NWCG Equipment Technology Committee

Equipment Bulletin: 25-002

Subject: Chaps, Chain Saw, M-2020, Nonconformities affecting use, appearance, and serviceability.

Figure 4: Front side of chain saw chaps. Black arrows showing the area of concern on the inner curve of leg. Orange arrows showing stitch line securing the binding tape.

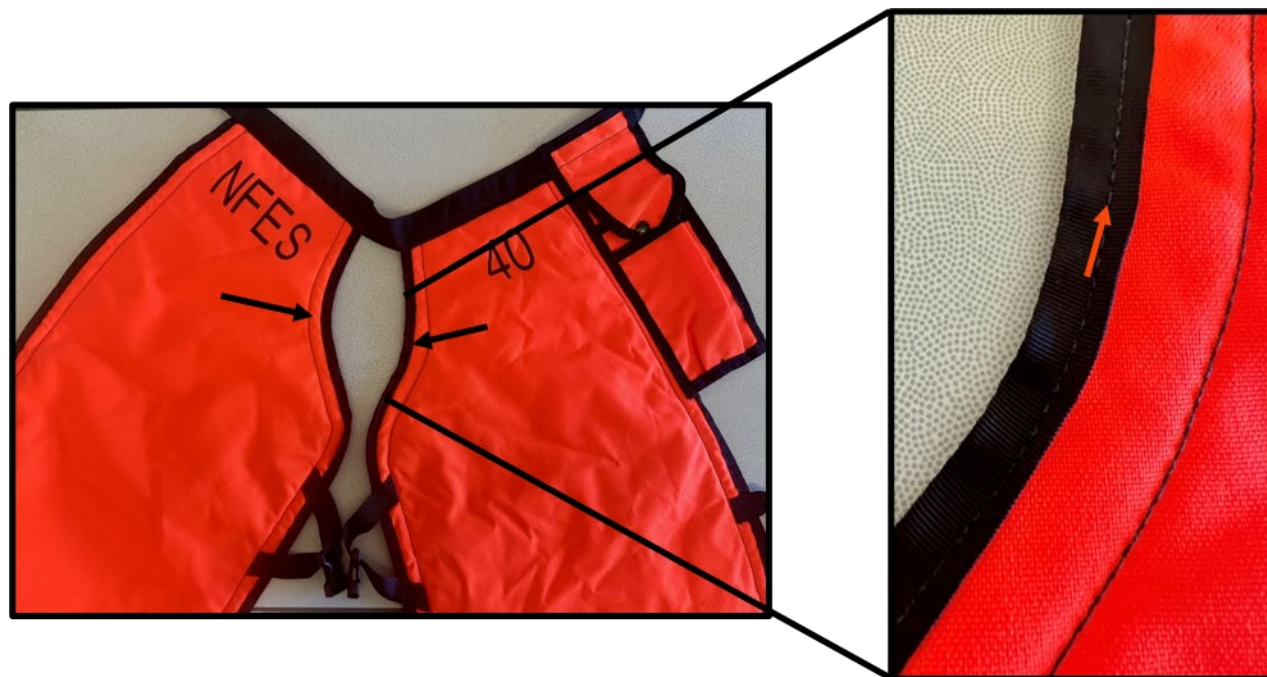
2. Inspect all binding tape to confirm the binding stitch line securely captures both the **front** and **back** shell (Figure 4), paying close attention to the curved inner leg. Lift the edge of the black binding tape to confirm the outer orange shell layers are captured by the stitching.

3. Remove chain saw chaps from service if the binding does not fully capture the outer shell layers.
4. Return any chaps with incorrectly sewn binding to the nearest cache. As stocking allows, caches will exchange for serviceable product. Cache locations can be found at:
<https://www.nwcg.gov/publications/pms449-1/nfes-national-interagency-support-caches>.

Figure 5: Kevlar fibers captured in binding.

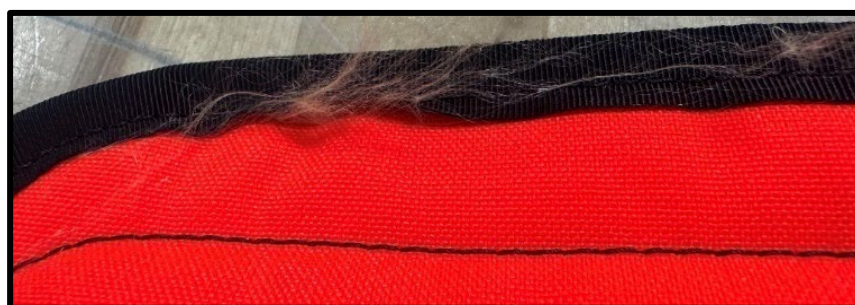
Note: Kevlar fibers were found captured in the binding during preliminary inspections (Figure 5). These fibers are easily removed and will not affect the performance of the protective pad. This does not indicate a nonconformity if the binding tape has fully captured the outer shell layers.
